Title - Sujet Greenstone Building Fit-Up	
Solicitation No. - N° de l'invitation EW038-172580/A	Amendment No. - N° modif. 005
Client Reference No. - N° de référence du client PWGSC EW038-172580	Date 2017-02-17
GETS Reference No. - N° de référence de SEAG PW-\$PWU-107-10995	
File No. - N° de dossier PWU-6-39304 (107)	CCC No./N° CCC - FMS No./N° VME
Solicitation Closes - L'invitation prend fin at - à 02:00 PM on - le 2017-02-21	Time Zone Fuseau horaire Mountain Standard Time MST
F.O.B. - F.A.B. Plant-Usine: <input type="checkbox"/> Destination: <input checked="" type="checkbox"/> Other-Autre: <input type="checkbox"/>	
Address Enquiries to: - Adresser toutes questions à: Anthony, Mary	Buyer Id - Id de l'acheteur pwu107
Telephone No. - N° de téléphone (780) 237-7582 ()	FAX No. - N° de FAX (780) 497-3510
Destination - of Goods, Services, and Construction: Destination - des biens, services et construction:

This amendment 005 has been raised to repost Addendum 03 with Electrical Addendum E-02

Electrical Addendum E-02

Project Name: PWGSC 3 rd Floor Renovation Greenstone Building	
Client: PSAV Architects Ltd.	
Project No.: 35004.00	Date: February 15, 2017
Distribution:	
Gene Drouin	PSAV A

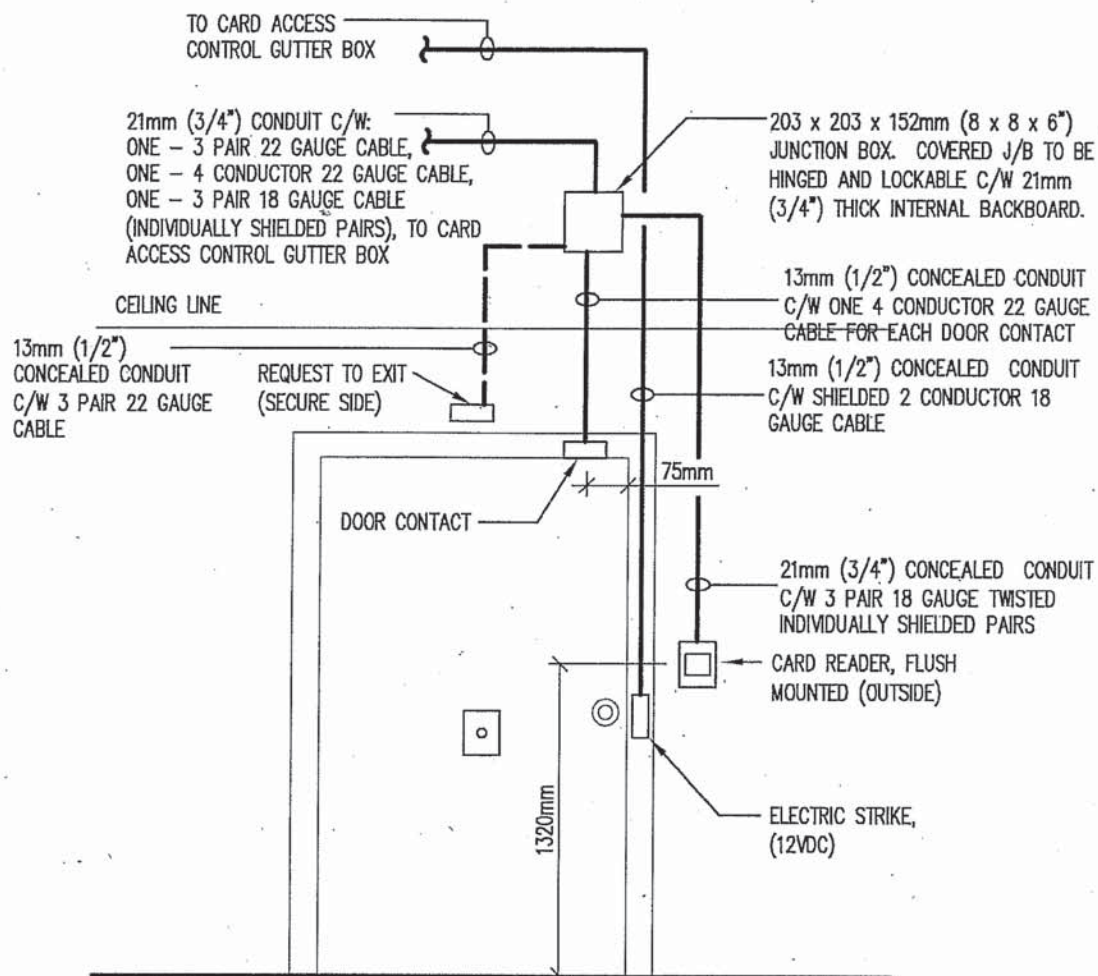
- .2 RFI Question: In terms of Security, the spec says to match existing wiring for devices. Little information is given for what is existing. A door detail of where the security devices are located, sizes of conduit needed and types of wire within them would be very helpful.

Response: The existing system is a Lenel Card Access system. Confirm door details onsite with system requirements. Assume the below elevation for pricing.
